Job:
RESIDENTIAL FLAT BUILDING: - 1147, 1149 PACIFIC HWY & 2 BOBBIN HEAD ROAD PYMBLE

Drawing title:
GROUND FLOOR PLAN

Scale: **1:100 @ A0**
Date: **22.07.2011**
Drawn: **JA**
Checked: **DM**
Drawing no.
SK05B

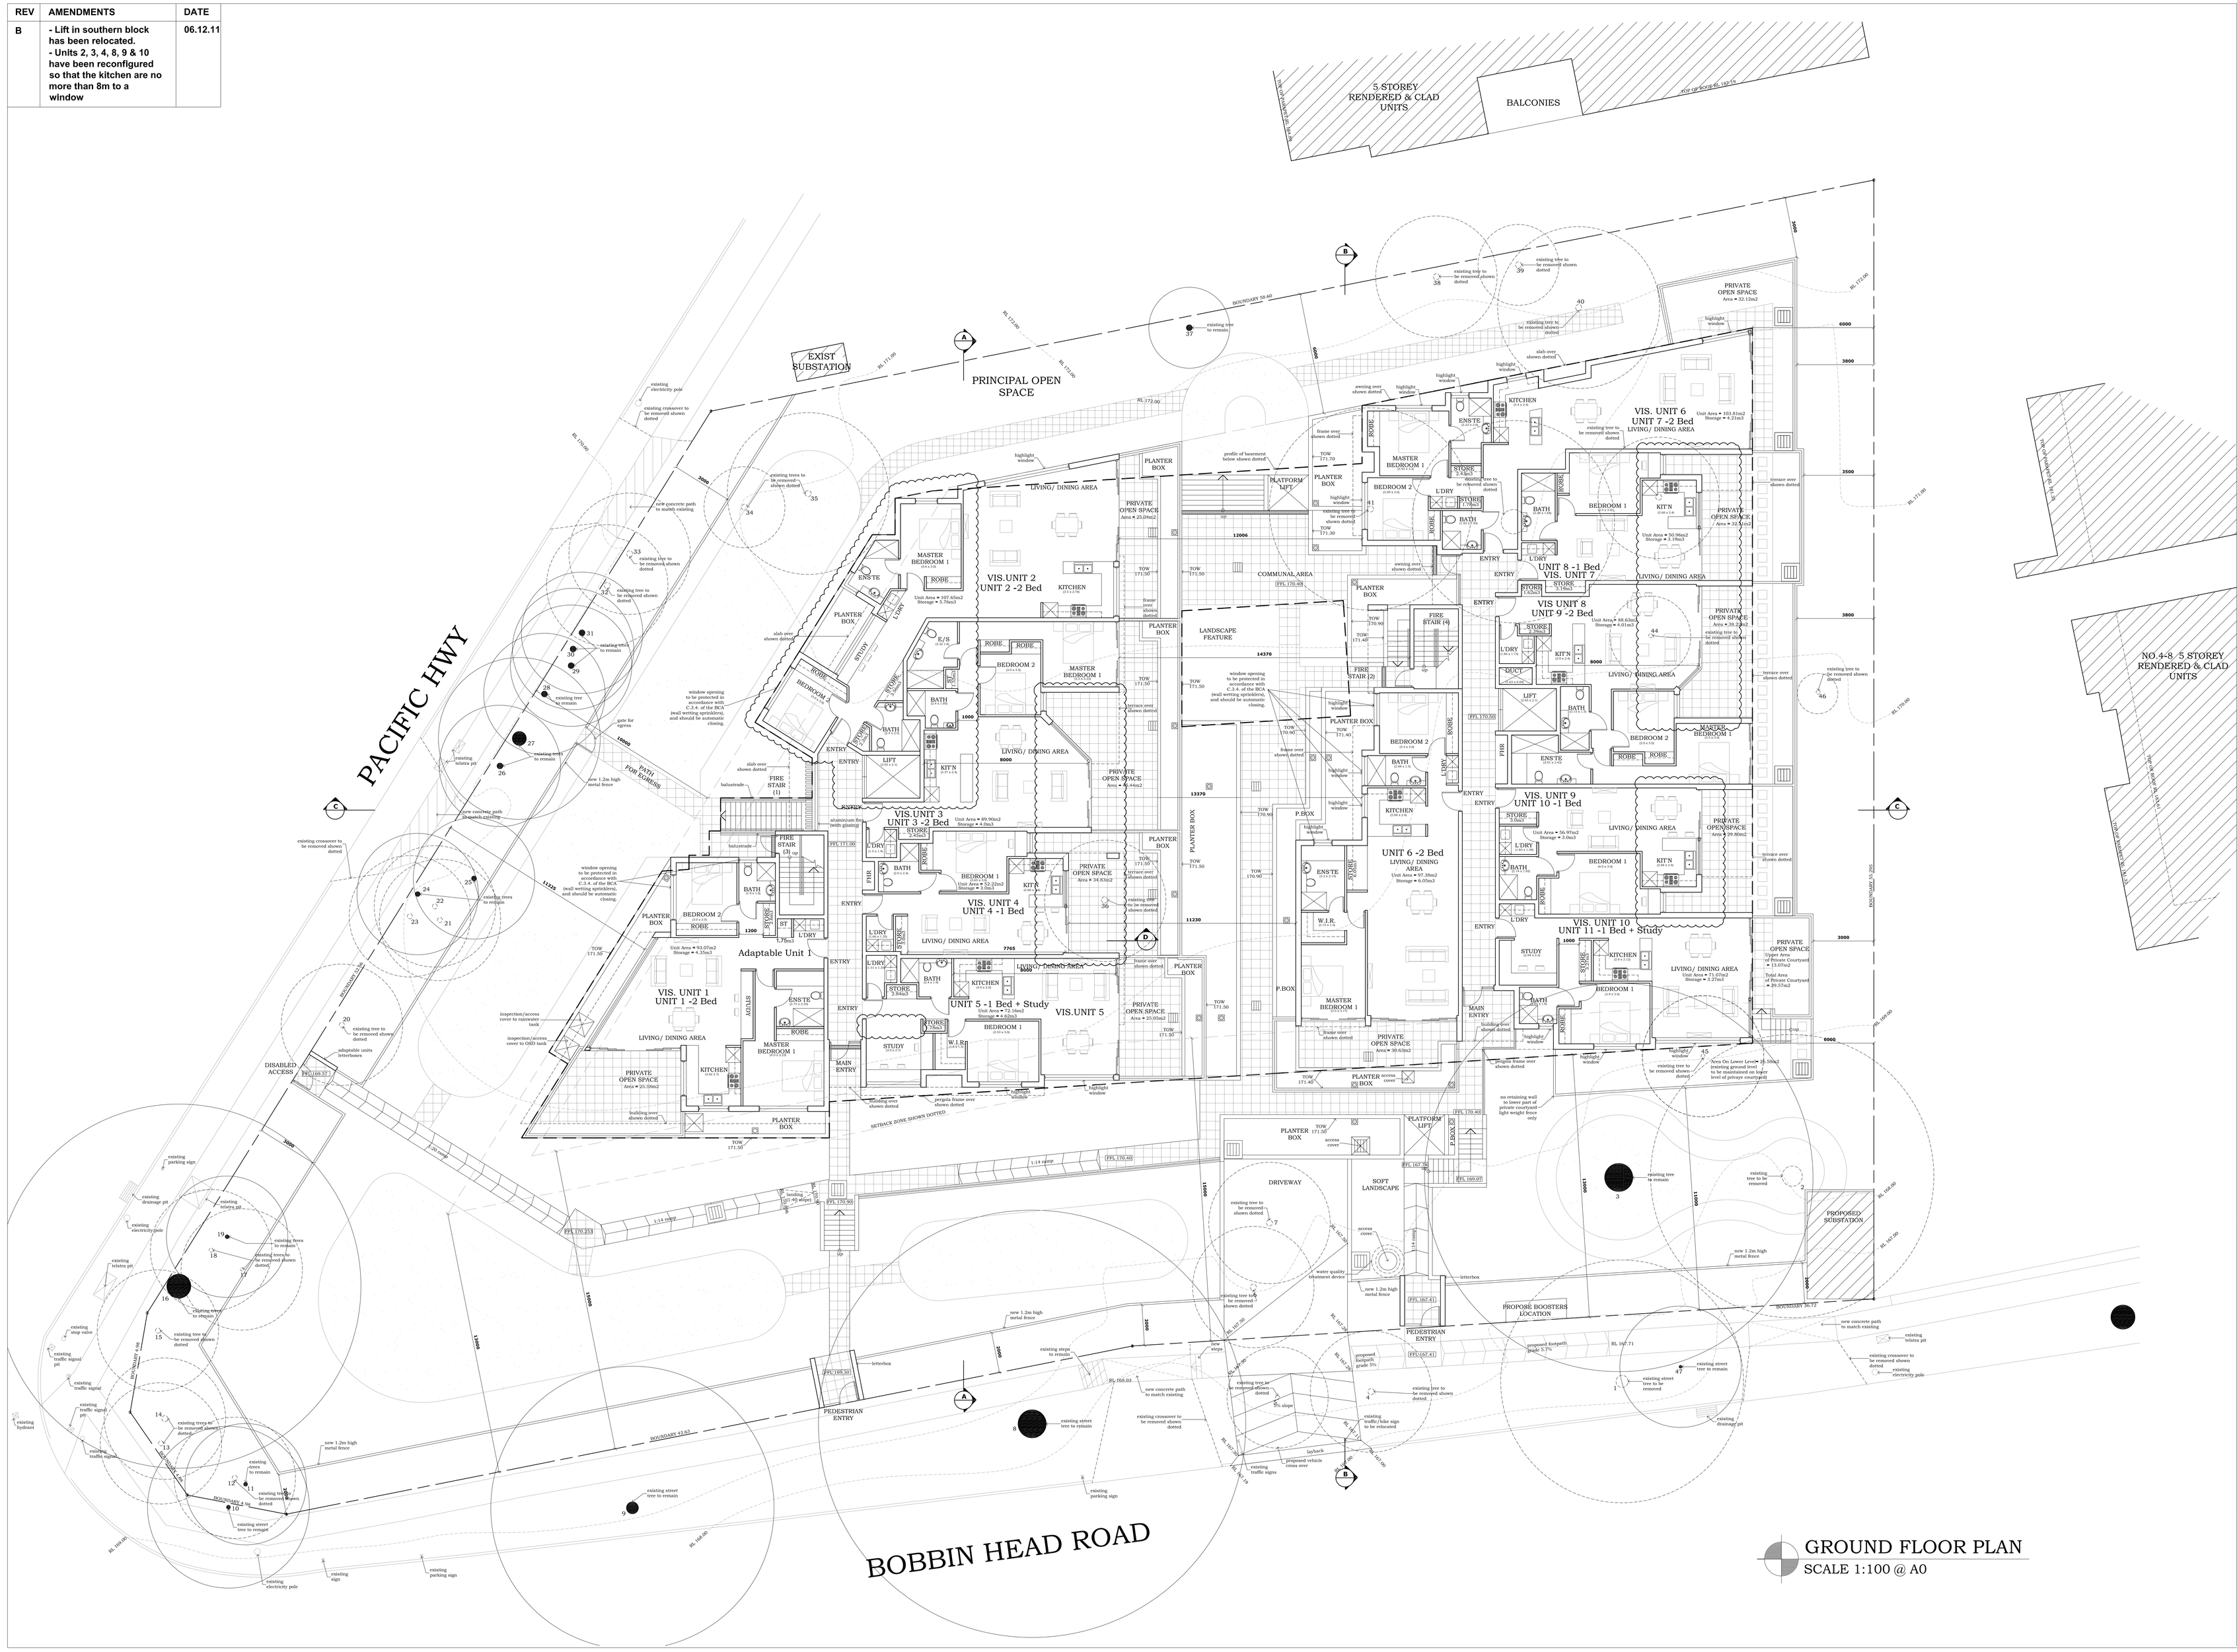
REV	AMENDMENTS	DATE
B	- Lift in southern block has been relocated. - Units 2, 3, 4, 8, 9 & 10 have been reconfigured so that the kitchen are no more than 8m to a window	06.12.11
